Deh Cho Bridge – Environmental Assessment Information Requests 2.1.1 – 2.1.21

Environmental Assessment of Deh Cho Bridge
Response to Mackenzie Valley Environmental Impact Review Board
Information Request

Title:	Yellowknife HWY #3, km 23 Deh Cho Bridge on Makenzie River SURFACE DRAINAGE DETAILS
Project:	
Drawing:	Fig. 2

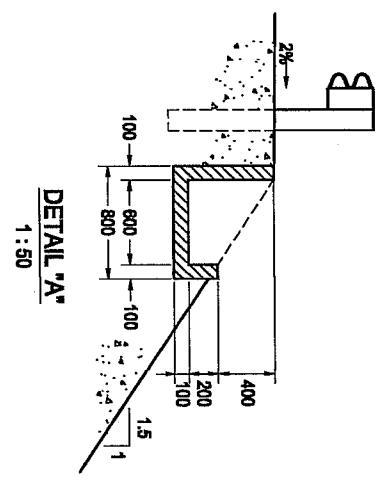
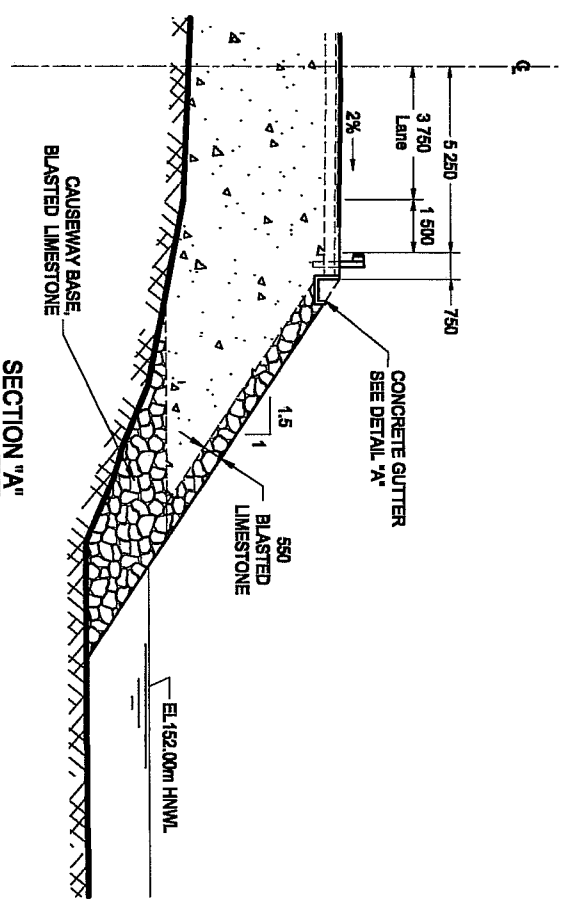
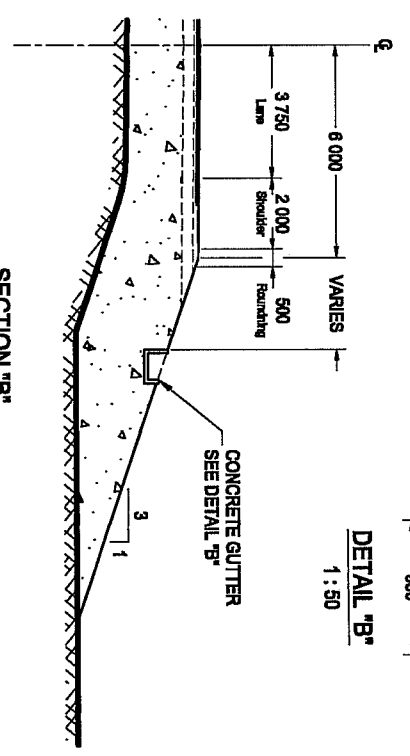
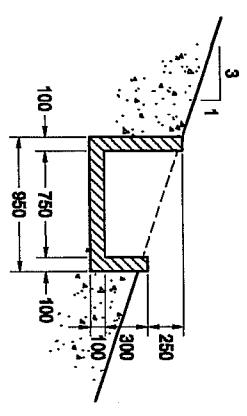
- a) There will be four containment ditches, two on each side of each approach. The ditches will be located 400 m to 500 m distant from the corresponding bridge abutment and not less than 50 m beyond the high water mark. Each ditch will be 20 m long 5 m wide, 0.5 m deep and of capacity exceeding 50 cu m. The longitudinal slope of the gutter that flows into the ditch is only 0.8%. In order to stabilize and protect the bed and banks from erosion the dykes around the ditches will be dressed with cobble size blasted rock and will be shaped and vegetated according to NT highway standards. Plan, profile, and details of the ditches are presented on Fig 1 and Fig 2.

In order to ensure a stable site, rock rip rap material will be incorporated into the design (e.g., at the interface between the sloped concrete gutters and the containment ditch). The ditches will be built of gravel capable to drain the water runoff and to contain the fuel in case of spill. The degree of soil contamination in and around the ditch in case of spill will depend on the moisture content of the gravel and on the time of response of the spill cleaning personnel mobilised by the responsible party.
